Equity Response 2017-0117 to Staff's January 12th Comments

WESTWOOD SHOPPING CENTER

SKETCH PLAN

IMPERVIOUS AREA WITHIN STREAM VALLEY BUFFER

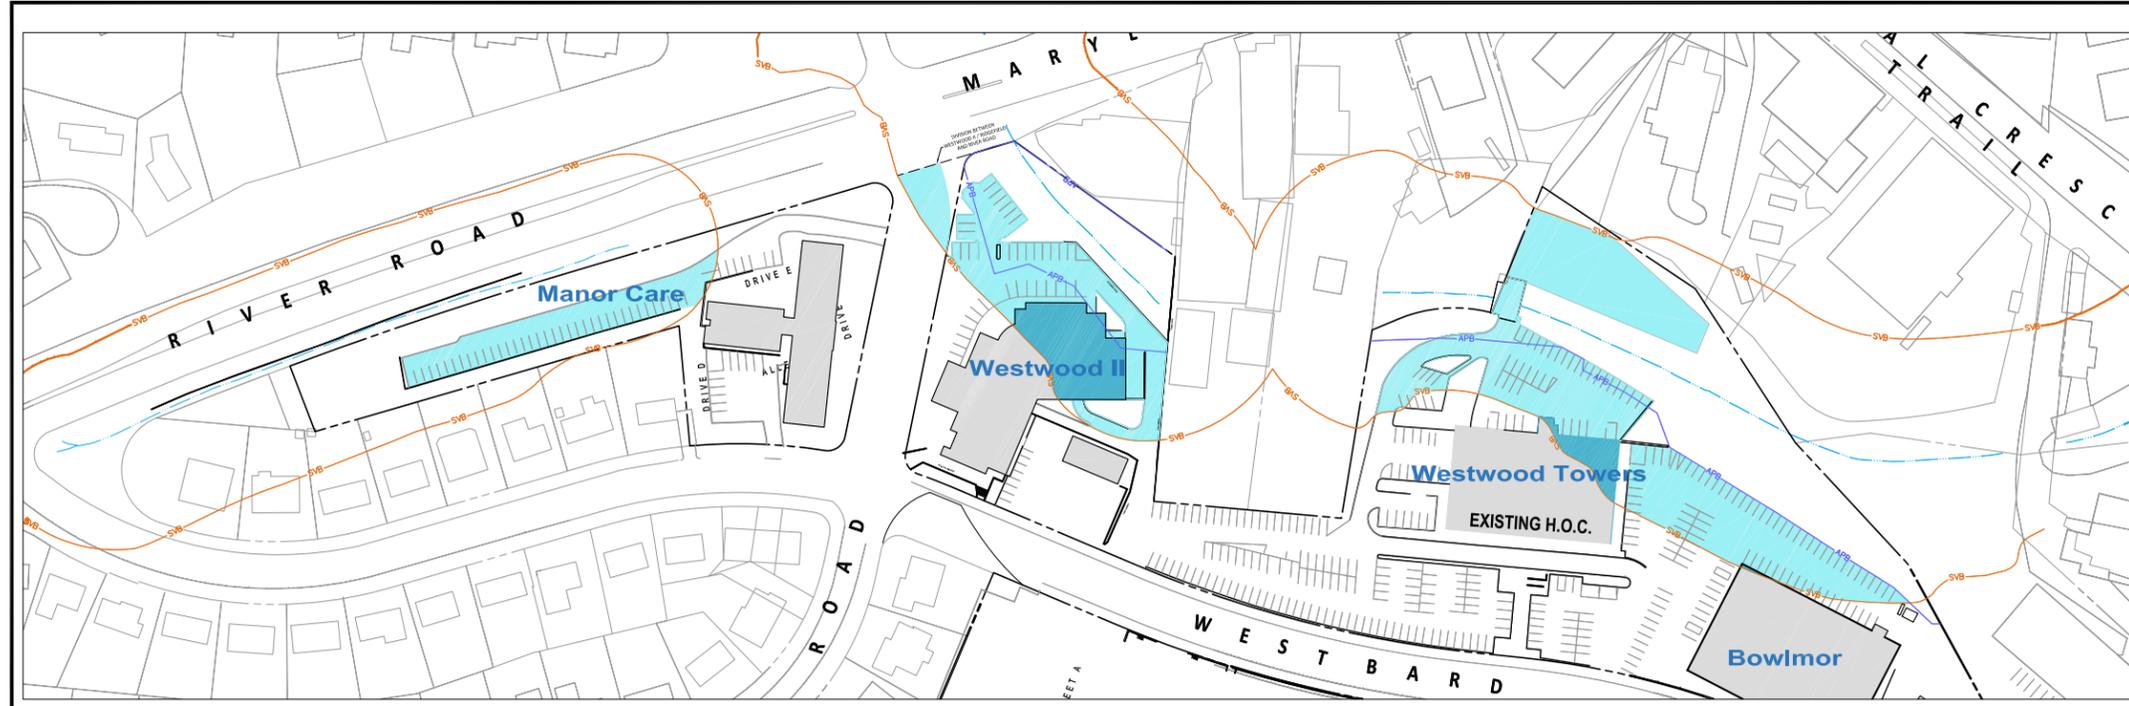
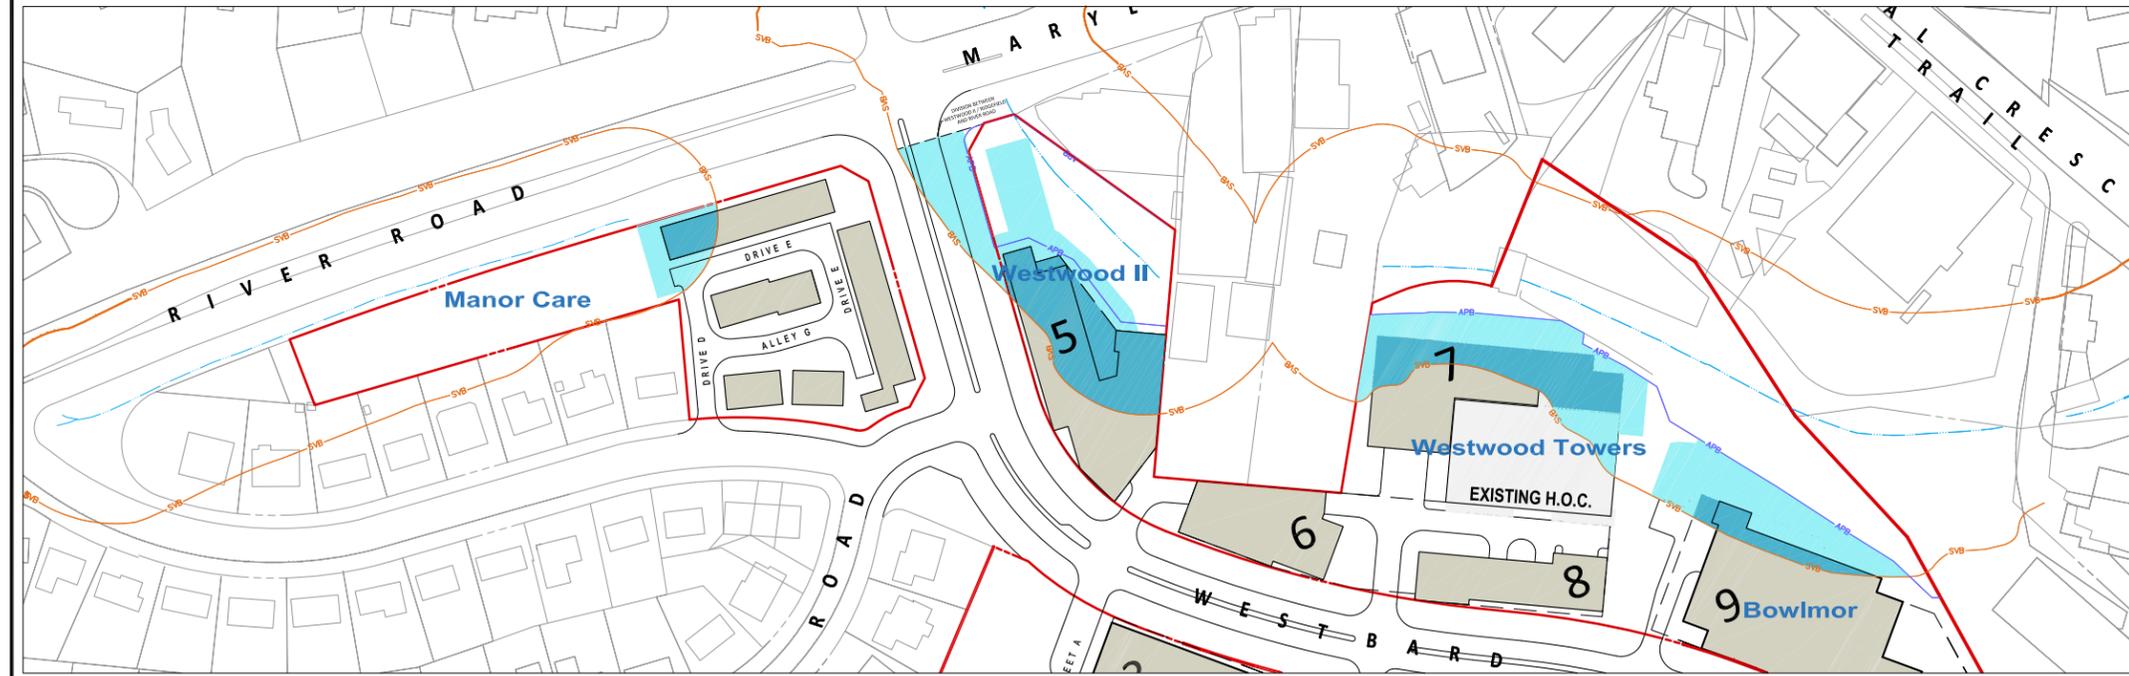
<p>9. Provide a breakdown per site and overall which compares the square footage of Staff’s proposed dedication, Applicants proposed dedication, existing SVB and existing/proposed SVB encroachments areas.</p>	<p>9. See new exhibit SK17 included with this submission.</p>
<p>10. APB (Applicant’s Proposed Boundary) should be changed to APD (Applicant’s Proposed Dedication) on all sheets.</p>	<p>10. As we discussed, Equity One is proposing a modification to the buffer, and therefore has retained the existing language of the plan. Equity One understands that the modified buffer line also represents a dedication line.</p>
<p>11. The Willett Branch is hatched as open space but not included in the open space calculation in the chart on SK3. It appears</p>	<p>11. The Willett Branch open space will be off-site after dedication. Therefore, a new color for off-site open space has</p>

SK2

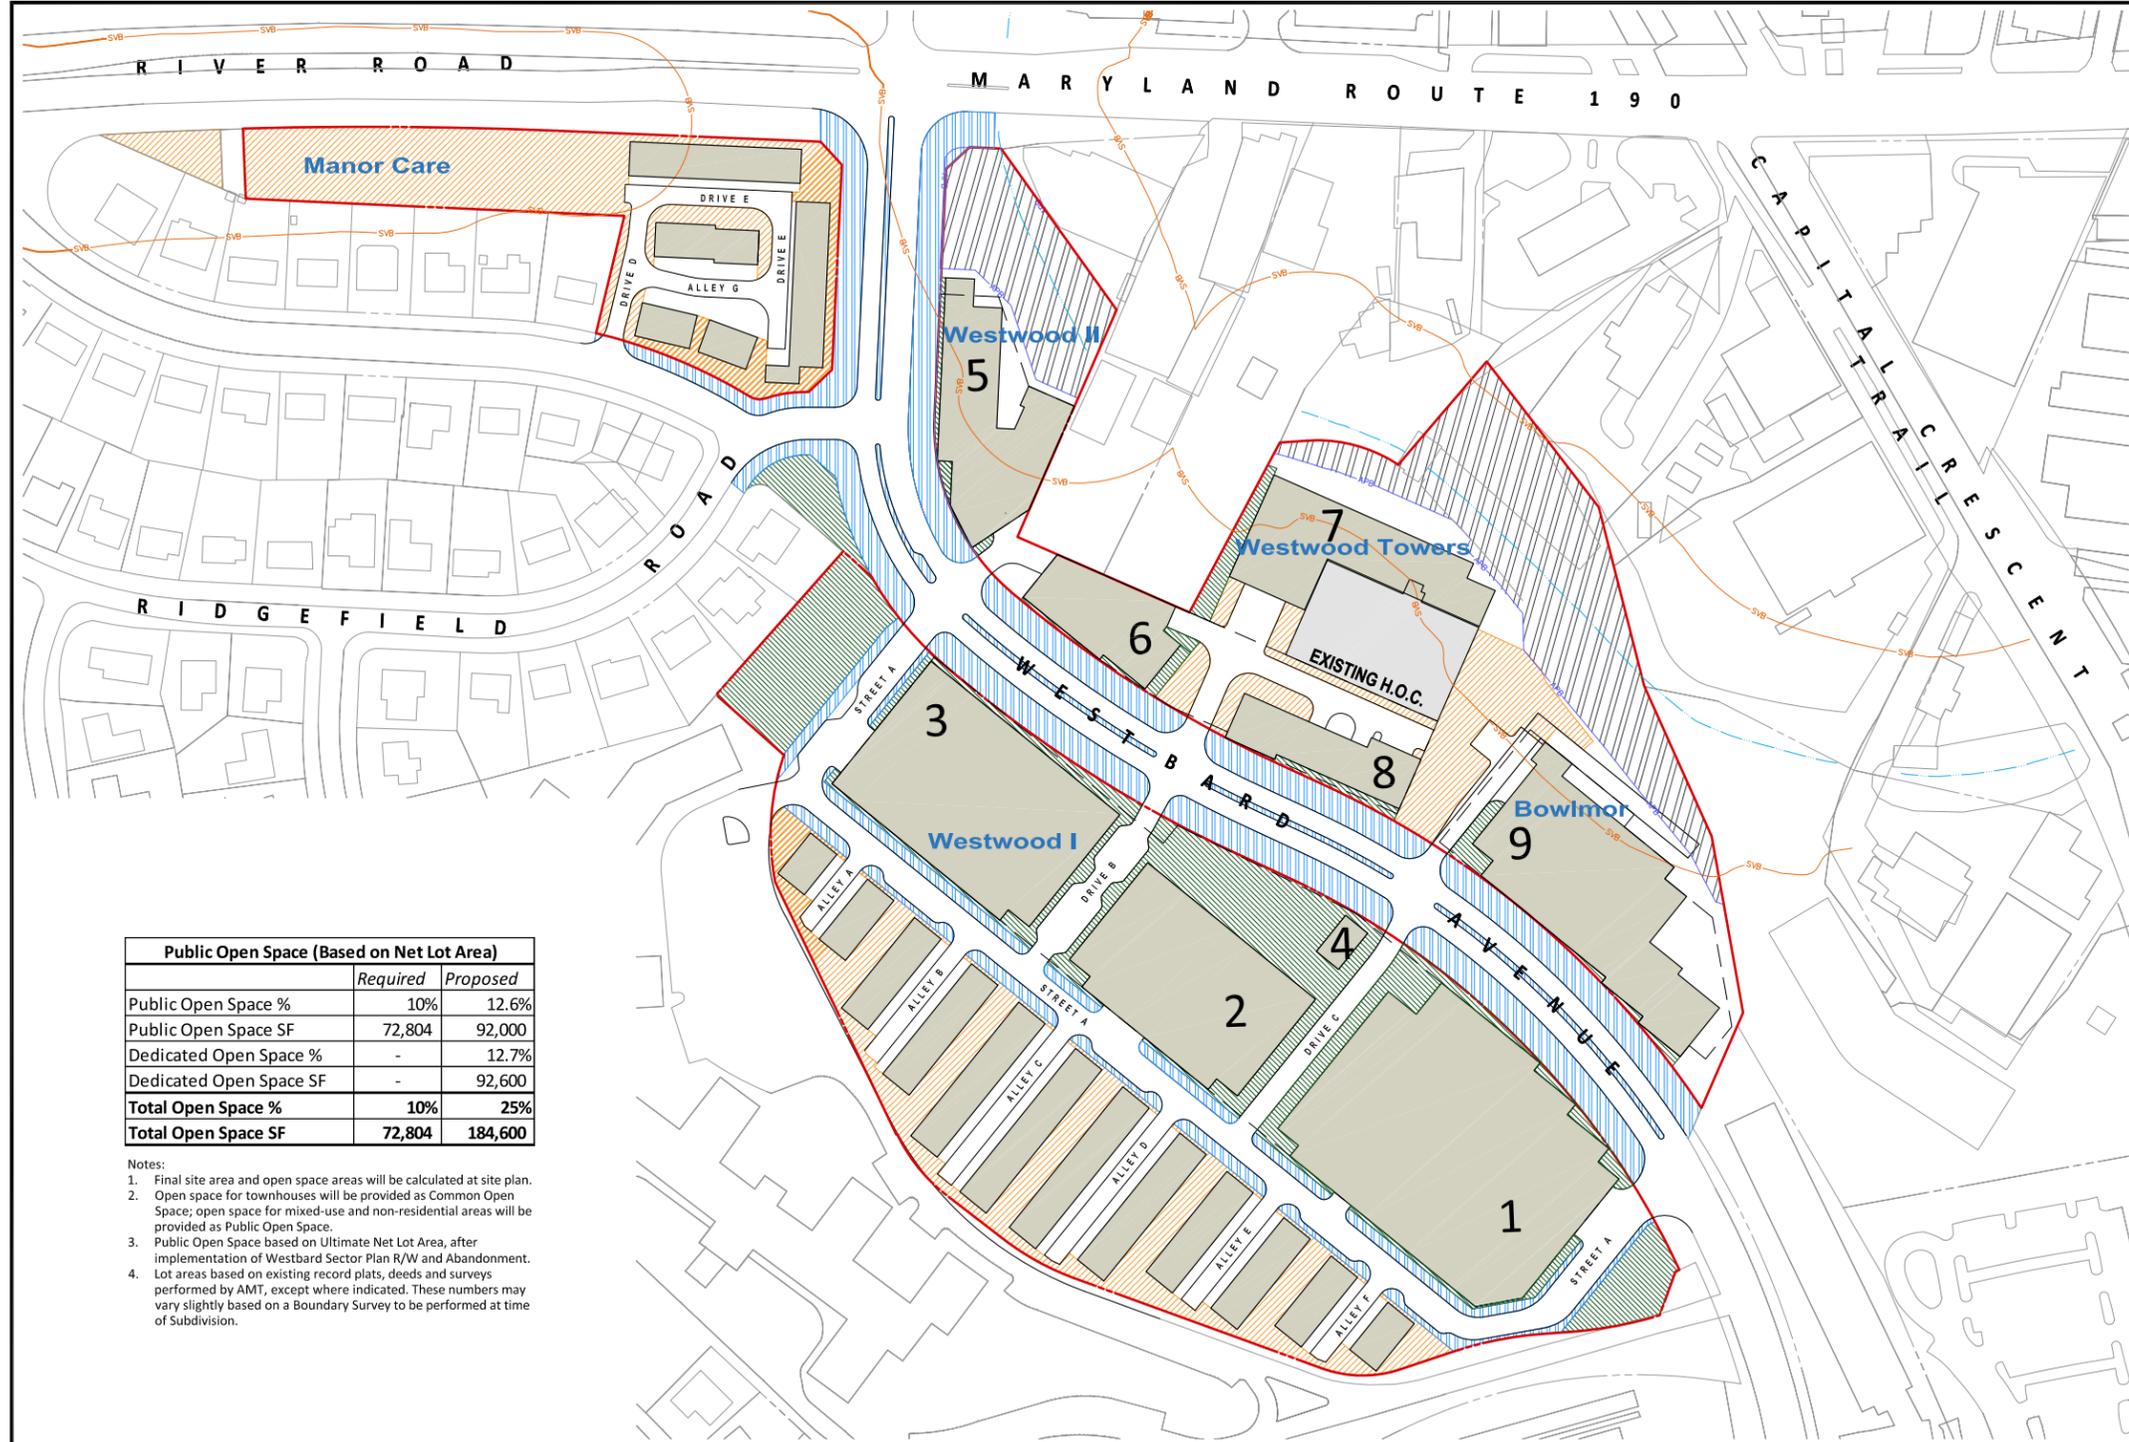
3. The Public Benefits point tally for Civic Space and Parks Dedication should be 23 points, not 9 points, per the 2015 Incentive Density Implementation Guidelines.	3. Per our subsequent conversations, this category has revised points; final points to be determined at time of site plan. See revised SK2.1

<p>25. On SK 2 and SK 10, please add an additional star behind HOC or move and enlarge the existing orange star behind the Bowlmor site so that the star/s better represent the extent of the greenway behind those buildings.</p>	<p>25. See revised SK2 and SK10. The star has been enlarged and moved more centrally.</p>
<p>26. The final resubmittal should recommend specific steps once the results of the archeological investigation is completed.</p>	<p>26. Per our discussion, details of the archeological investigation will be addressed at Preliminary Plan.</p>
<p>27. If the garage attached to the HOC building is accepted it needs to show a proposed height on sheet SK2. The way it is currently portrayed it could go to 165 feet. It needs a circle with proposed numbers.</p>	<p>27. See revised SK2. A proposed maximum height of 70 feet has been added to this element.</p>
<p>28. On SK 3 the Applicant's Proposed Dedication Line behind HOC appears too far from the proposed building based on previous discussions between staff and the Applicant.</p>	<p>28. The line has remained as it was, but the building has gotten thinner, to allow for SWM facilities on the lot.</p>

SK2.1: PUBLIC BENEFIT TABLE

Public Benefit Point Tally	
Major Public Facility	
Civic Space & Parks Dedication	24 Points
Connectivity & Mobility	
Way Finding Signage	5 Points
Bikeshare Station	10 Points
Private Shuttle Service to METRO	20 Points
Quality Building & Site Design	
Structured Parking	20 Points
Exceptional Design	10 Points
Diversity of Uses & Activities	
*Moderately Priced Dwelling Units (MPDUs)	30 Points
Small Business Opportunities	20 Points
*Total	139 Points

SHEET No:
SK5
320170010

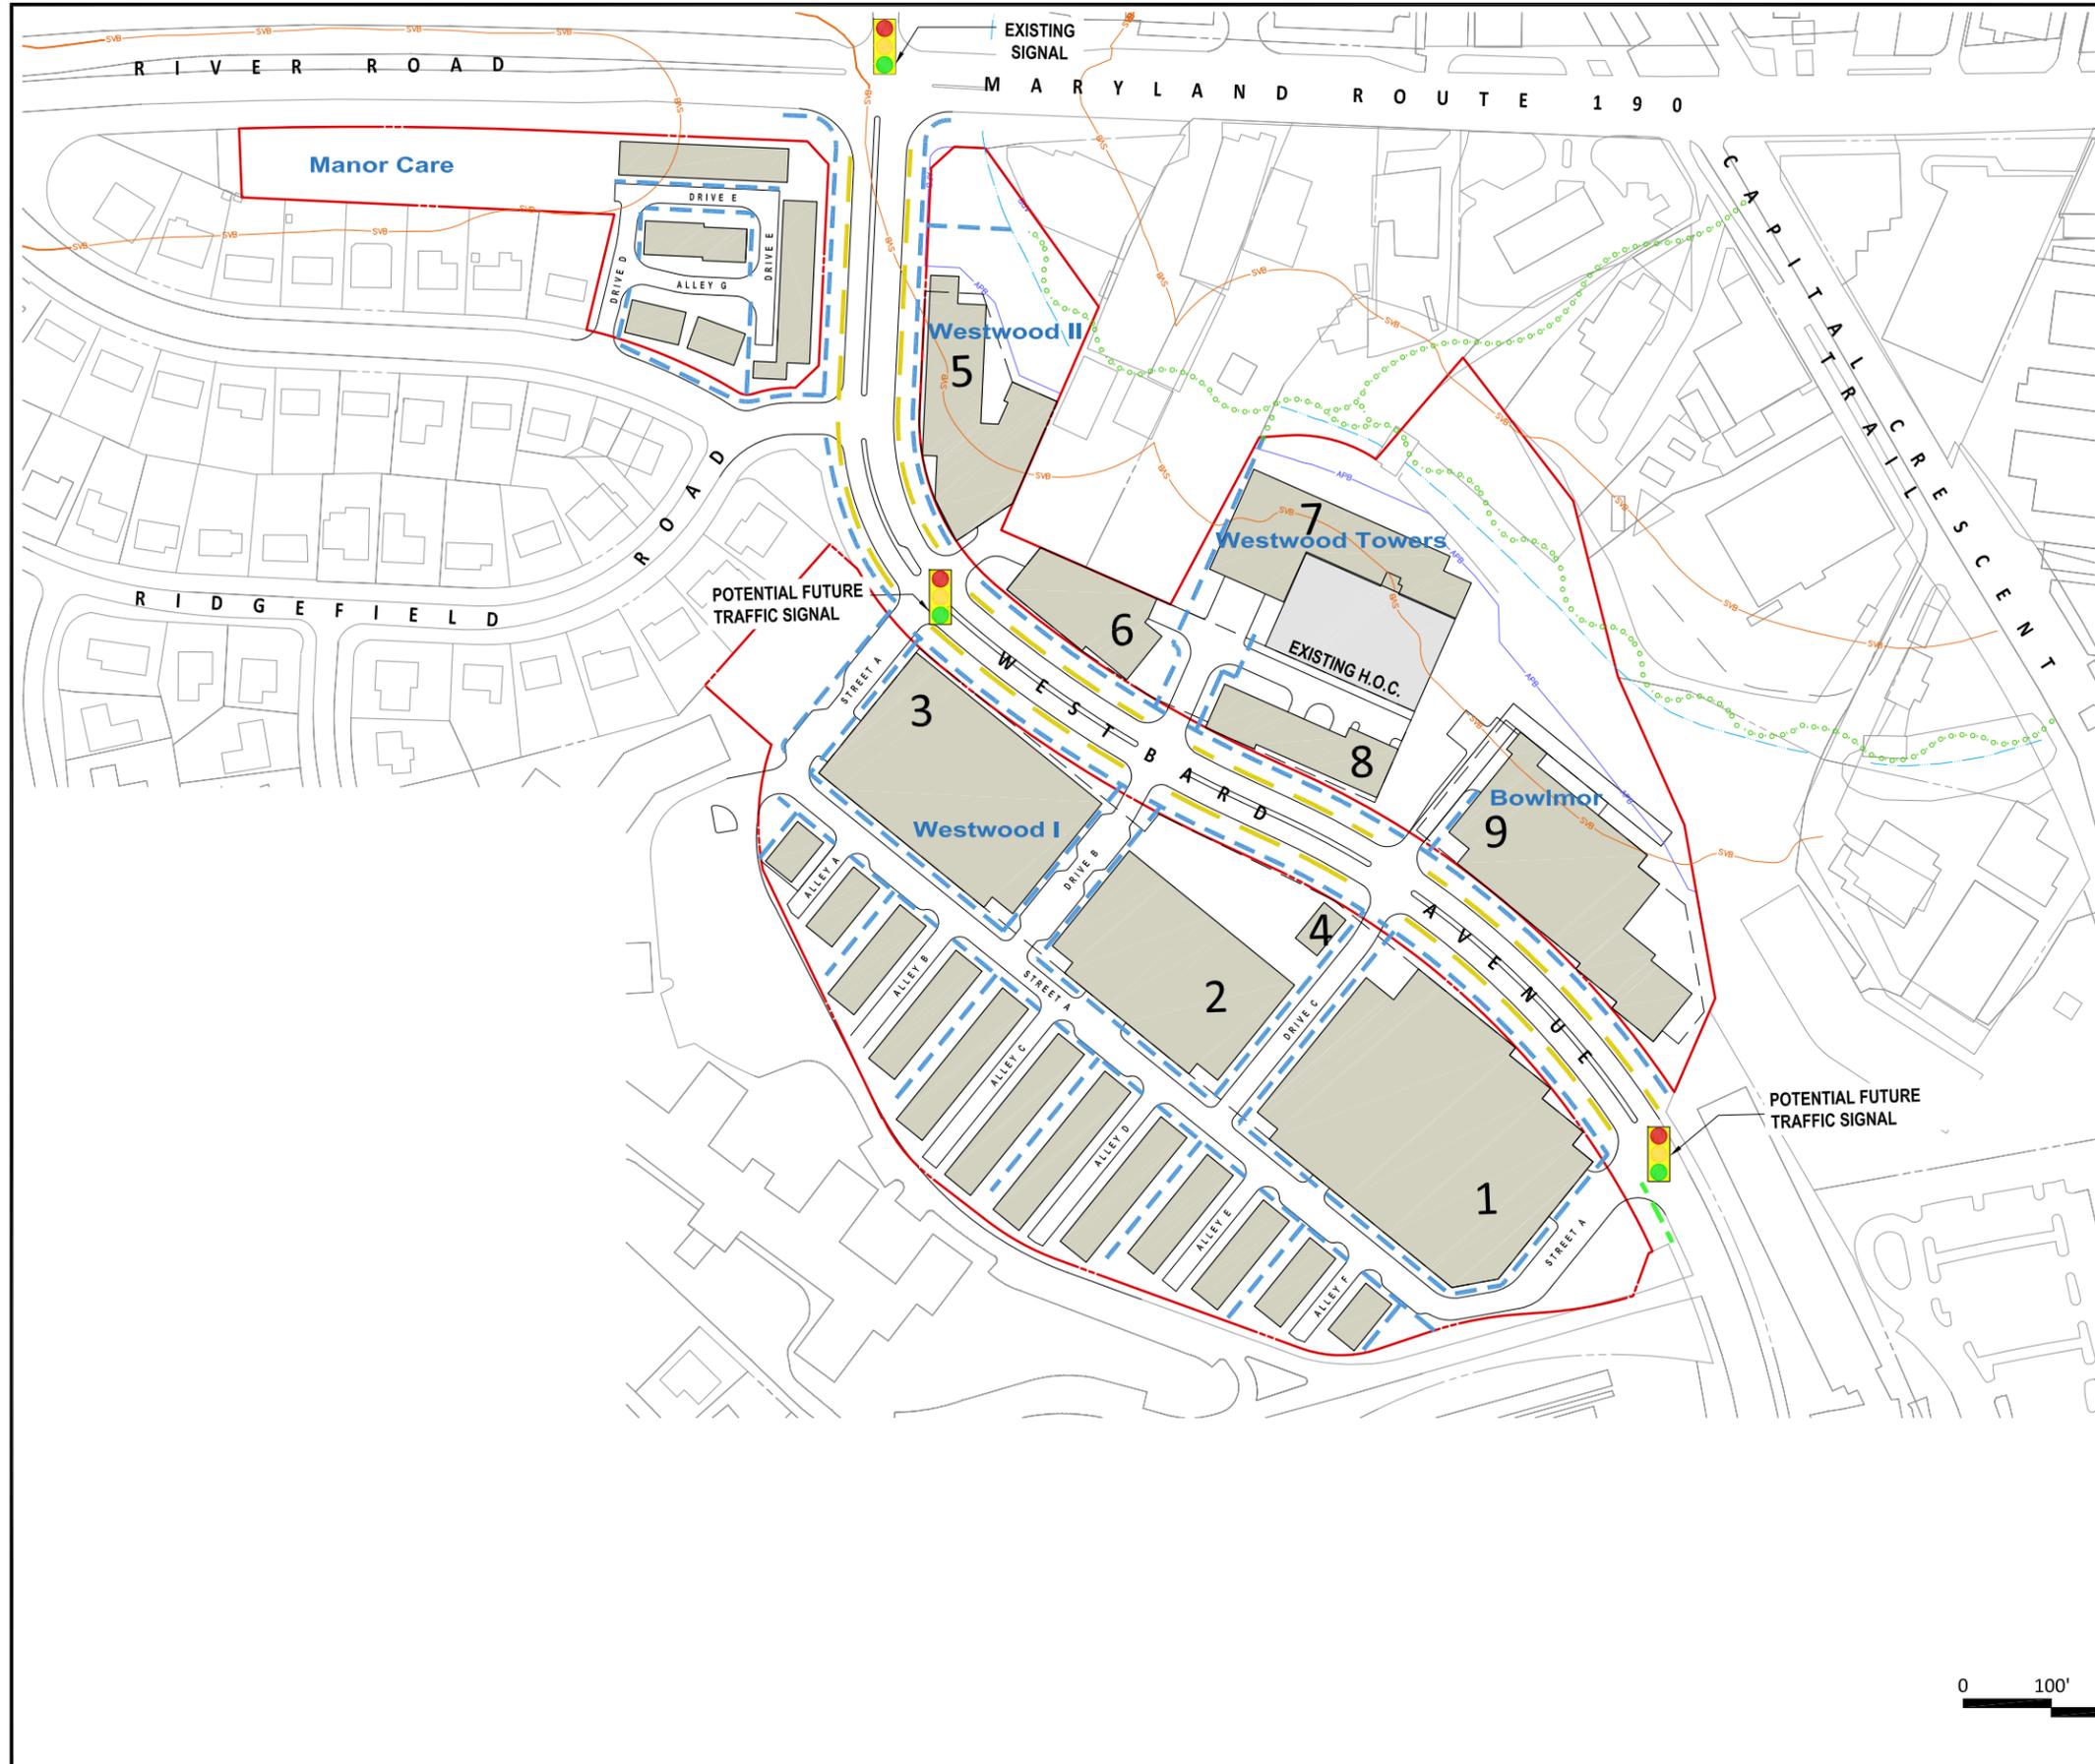
<p>that the proposed 10% open space has not changed significantly since the September resubmittal even though the Willett Branch is now included. Please confirm the amount and correct the table.</p>	<p>been added, and the total reflects dedicated open space in addition to the open space provided on site.</p>
<p>12. The connection at American Plant Food shown at SK8 and SK9 is not accurate - the land bridge over the Willett Branch will be removed in the final state.</p>	<p>12. See revised sheets SK8 & SK9.</p>
<p>13. On SK 3 please differentiate the colors / symbology between the Private Open Space and Public Open Space.</p>	<p>13. See revised SK 3. Public Use Space, Private Open Space and Willett Branch Dedication Open Space are each different colors now.</p>
<p>14. On SK 5 the pedestrian movement by others should not show the Applicant's proposed trail alignment since the trail alignment is still conceptual and instead should show a line that generally follows the stream centerline, connects to the applicant's pedestrian movement line shown along the north side of the HOC building and then crosses behind the HOC building to connect back up to River Road.</p>	<p>14. See revised sheet SK5.</p>
